Index 102-608

Two-Lane, Two-Way, Temporary Diversion Connection

COMMENTARY

Sheet 1: Revised Detail and Notes; Deleted Conditions.

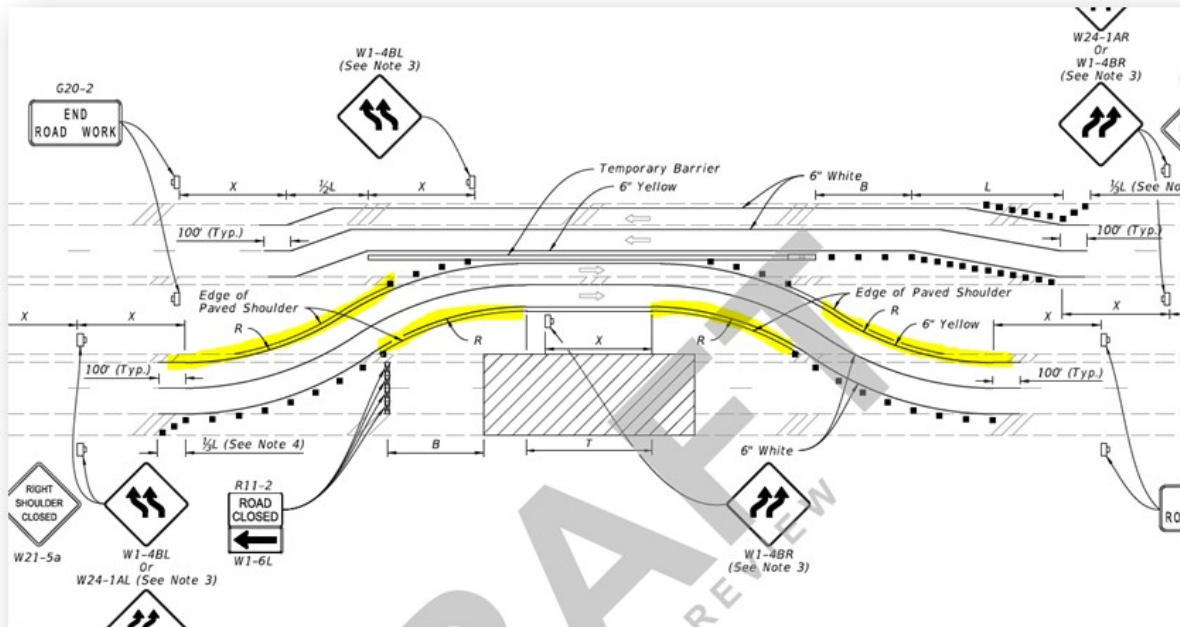
COMMENT: Reverse curve signs within diversion need to be reversed to mimic condition correctly (WI-4L should be WI-4R, and vice versa)

RESPONSE: *Agreed*

Change Made: *Sign call-outs have been switched to correct L/R orientation*

**TWO-LANE, TWO-WAY
TEMPORARY DIVERSION CONNECTION**

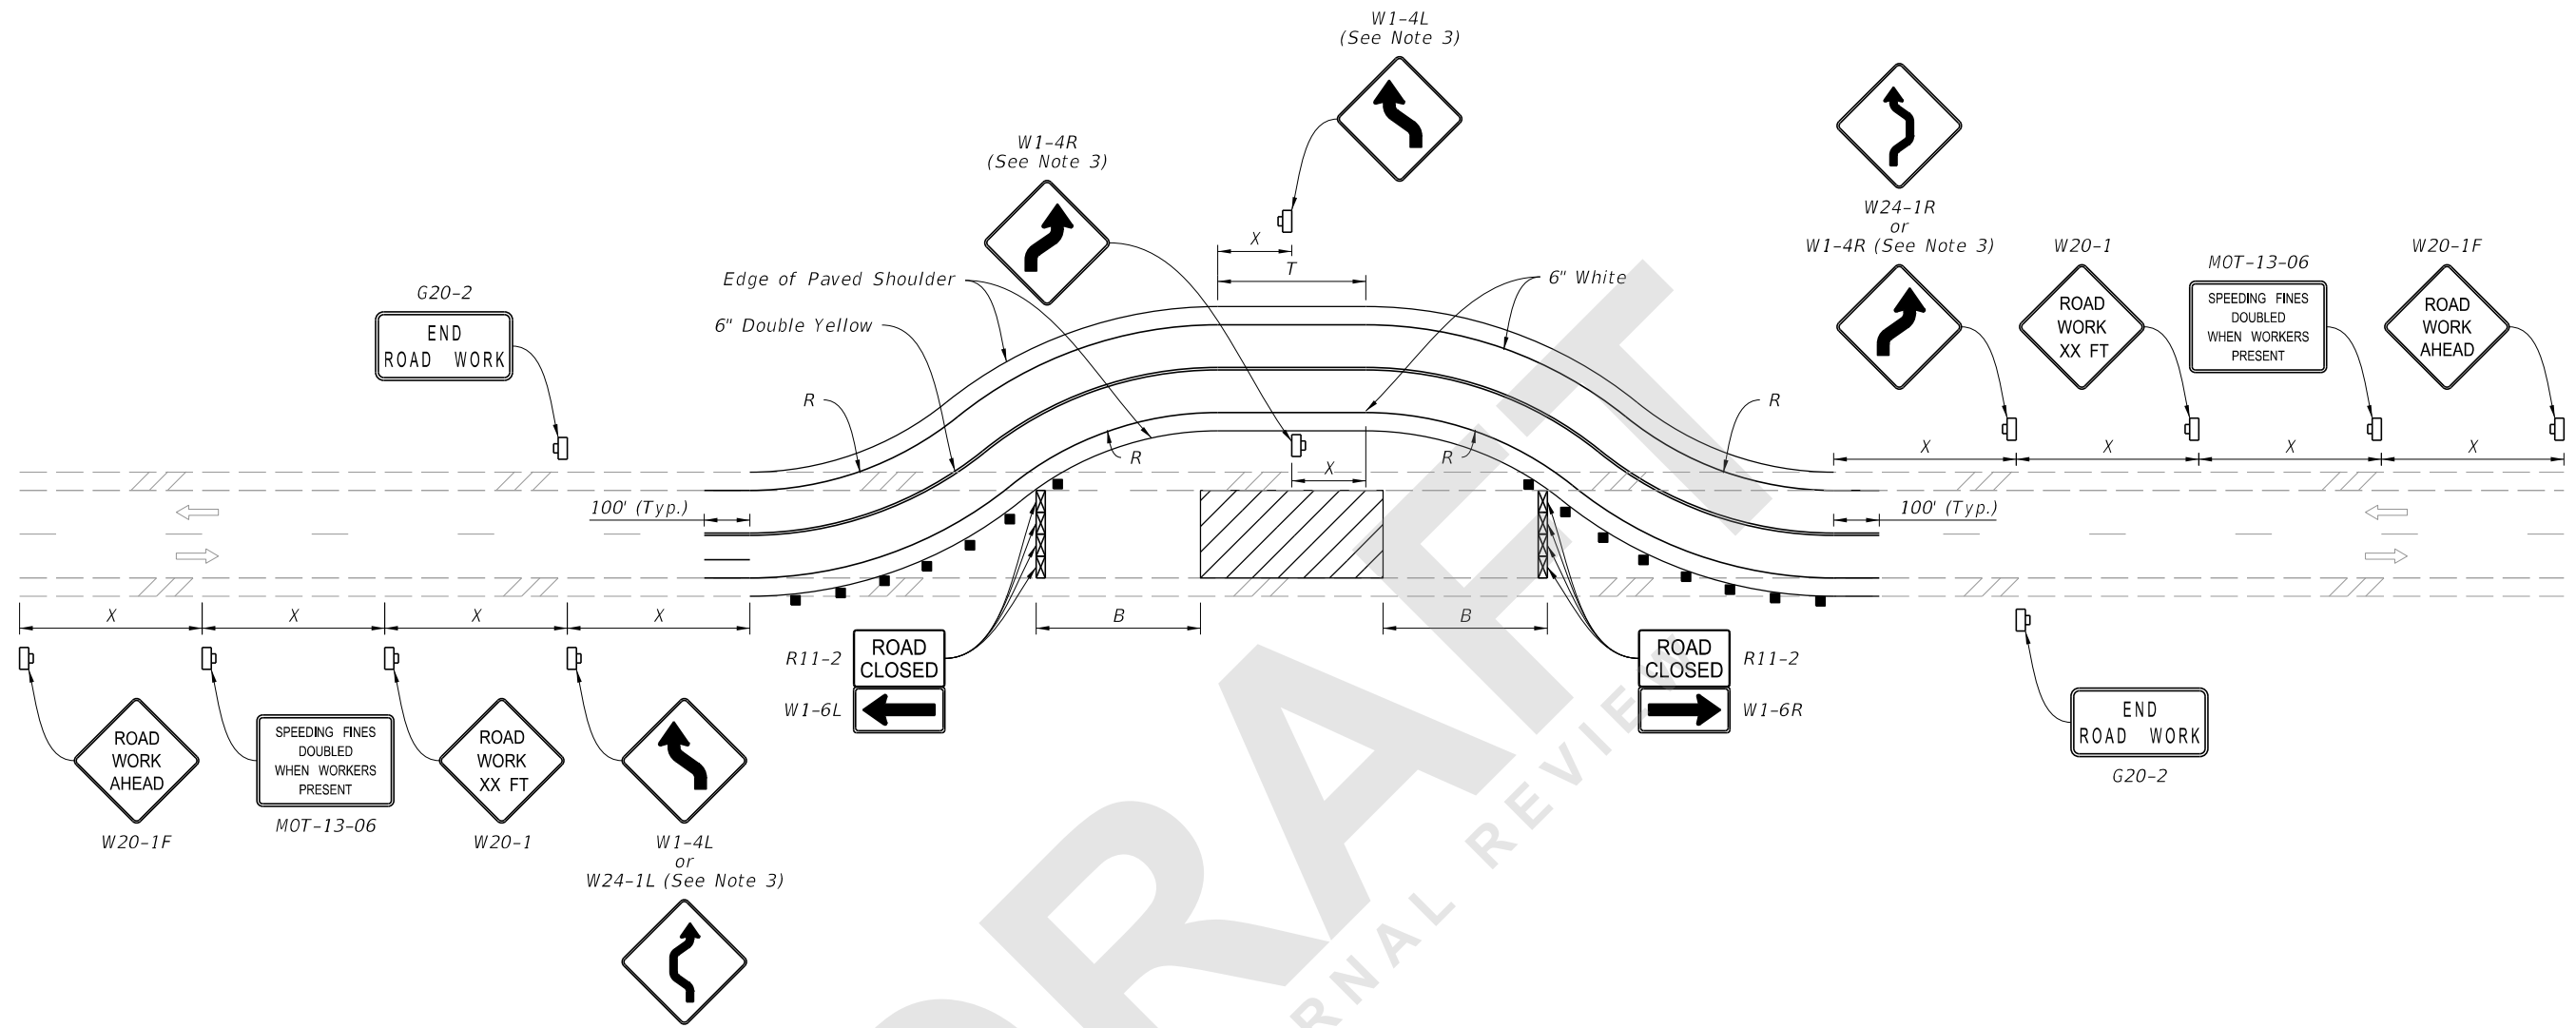
1. The W1-4L and W1-4R at the center of the diversion are incorrect. W1-4L is shown at the right side, but due to the arrow deflection (shown on the sign) it should be on the left side facing traffic heading to the right. W1-4R should be on the right-side facing traffic heading to the right.

2. Why are there no channelization devices on the left side edge? Why there are no channelization devices at the tangent portion?

3. Why are we not showing signs like "Road Work 1 Mile Away"? When required the intent of these type of signs was to call attention ahead of time and keep reinforcing the message. At higher speeds drivers tend to miss signs and everything is coming fast. We need to give advance warning and reinforce the message several times.

4. Consider adding a note referring to 102-600 for the Speed Reduction signs. In this scenario we tend to reduce the speed.

COMMENT: Index 102-608. Sheet 1/1 – Check for conflict with RPM Supplement in Index 102-600. Sheet 11/11 or include note in sheet 1/1 with reference to Index 102-600. Sheet 11/11 in Index.

COMMENT: If barrier wall is placed in the area highlighted below sight distance must be accounted for around the inside of the curve. We have several projects where we have implemented diversions and due to the limited space available barrier wall had to be placed on both sides of the diversion and stopping sight distance must be taken into consideration. Adding a note to alert the contractors and EOR would be beneficial.

RESPONSE: *Agreed*

Change Made: *Sign call-outs have been switched to correct L/R orientation*

RESPONSE: *Channelizing devices should be used to direct traffic into an altered condition or to delineate areas traffic should not enter (i.e., the work area). Additionally, the MUTCD does not use channelizing devices on the outside of lane shifts. Within a diversion temporary striping delineates lane location/width.*

RESPONSE: *Depending on if there is a Speed Reduction or not, the proposed signs would extend from between 6,000 and 9,000 feet which is further than the current requirements.*

RESPONSE: *Comment acknowledged; however, speeds reduction signing is controlled by Index 102-600 which applies to the entire 102 Series of Indexes.*

RESPONSE: *No conflicts are noted. The RPM placement details included on Index 102-600 Sheet 11 of 11 provide RPM placement requirements regardless to TCC configuration. The Two-Lane, Two-Way Temporary Diversion is used as an example for this roadway type.*

RESPONSE: This recommendation is acknowledged; however, sight distance should be a consideration for all TTC devices; as such, considerations are addressed in the FDM and on Index 102-600.
